Access Compliance Report

Public Rights-of-Way

(Pedestrian Signals)

Intersection ID: N/A	Main Street:	Cross Street: N/A	Location: N/A
ADA ID: A49CAE5732A0	Signal Type: One Push Button-Non APS	Overall Compliance: No	Severity Score: BTN 1: N/A BTN 2: N/A No BTN: N/A
Codes/Mitigation Info/Possible Solution		Field Measurements/Component Compliance

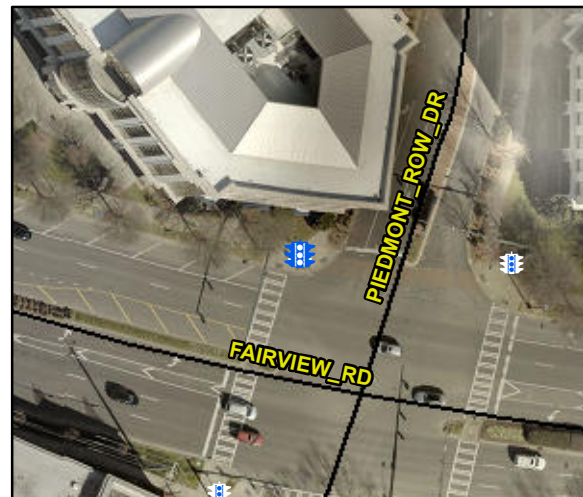
PROW/ADA: TMUTCD 4e.08, R404.2, R406.2

Yes	B 1 Clear Xing Direction?	ClearlyMarked	N/A	B 2 Clear Xing Direction?	N/A
	B 1 Crossing Direction	To S		B 2 Crossing Direction	N/A
Yes	B 1 DistanceTo XWalk (in)	44.0	N/A	B 2 DistanceTo XWalk (in)	N/A
No	B 1 DistanceTo Curb (in)	89.0	N/A	B 2 DistanceTo Curb (in)	N/A
Yes	B 1 Diameter (in)	2.0	N/A	B 2 Diameter (in)	N/A

Possible Solutions: Replace Signal Push Button With APS Button on New Post. Remove & Relocate Sign.
